## SUMMARY OF CONCERNS IN RELATION TO THE PROPOSED NORTHCONNEX TUNNEL

**This is an objection to many aspects of the proposed NorthConnex tunnel.**

MOTORWAY OPERATIONS COMPLEX - SOUTHERN VENTILATION FACILITY - SECTIONS  
M1-M2-5000-DR-JD-0525

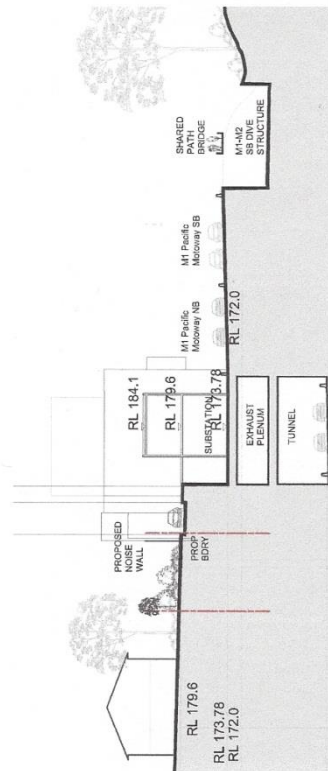
5. *EIS Volume 4, Technical working papers - Urban Design, 6.0 Operational Ancillary Facilities*  
EIS Page 99 there is the diagram "Motorway Operations Complex – Southern Ventilation Facility – sections. *Page 10 below* The diagram has the cryptic label "Connection to tunnel TBC". What does TBC stand for? To be considered? Why is tunnel singular? Which tunnel is the diagram referring to northbound or southbound? There is no diagram showing any connection from the Southern Interchange ventilation facility to either the northbound or the southbound tunnel in any way AND YET ....

- Diagrams need to be provided showing the inter-relation between the shaft, the ventilation outlet and the motorway operations centre with a clear description of what is to be constructed and how it will operate.
- The community needs irrefutable evidence that the polluted air from the southbound tunnel exit portals will not be allowed to flow like an invisible sewer through West Pennant Hills, North Rocks, Carlingford and Beecroft.

M1-M2-5000-DR-JD-0550  
NORTHERN VENTILATION FACILITY - CROSS SECTIONS

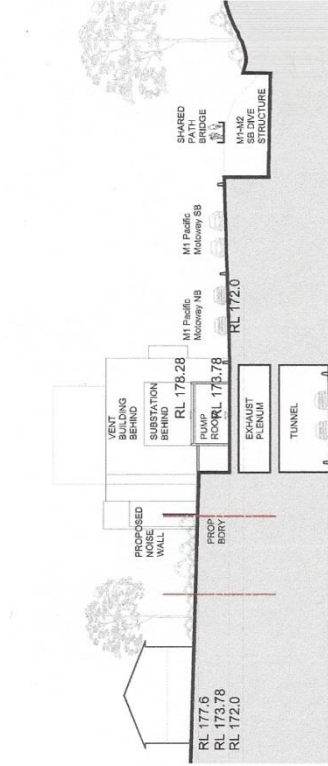
EIS page 135 *Page 11 below* there is a very explicit diagram showing the *Northern Ventilation Facility – cross section*.

Why are there no comparable diagrams for the Southern Interchange and the Southern Ventilation facility?

MOTORWAY OPERATIONS COMPLEX - SOUTHERN VENTILATION FACILITY - SITE SECTION 1-1  
M1-M2-5000-DR-UD-0713

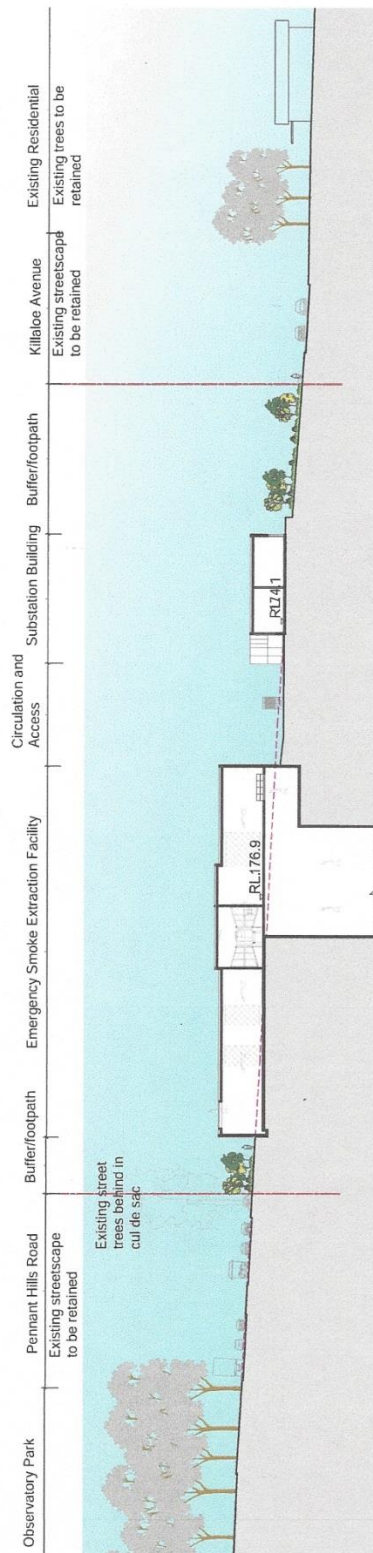
6. *EIS Volume 4, Technical working papers Urban Design, 8.0 Landscape Design*  
EIS Page 176 is the diagram "Motorway Operations Complex – Southern Ventilation Facility – Site 1-1". *Page 13 below* The diagram does not show any connection to either the northbound or southbound tunnel. In the same Landscape Design section, EIS Page 182 is the diagram "Wilson Road Tunnel Support Facility –Section" *Page 14 below* which clearly shows the connection to the tunnels. In the same Landscape Design section, EIS Page 189 is the diagram "Northern Ventilation Facility – Landscape Concept Section". *Page 15 below* This also clearly shows the connection to the tunnels.
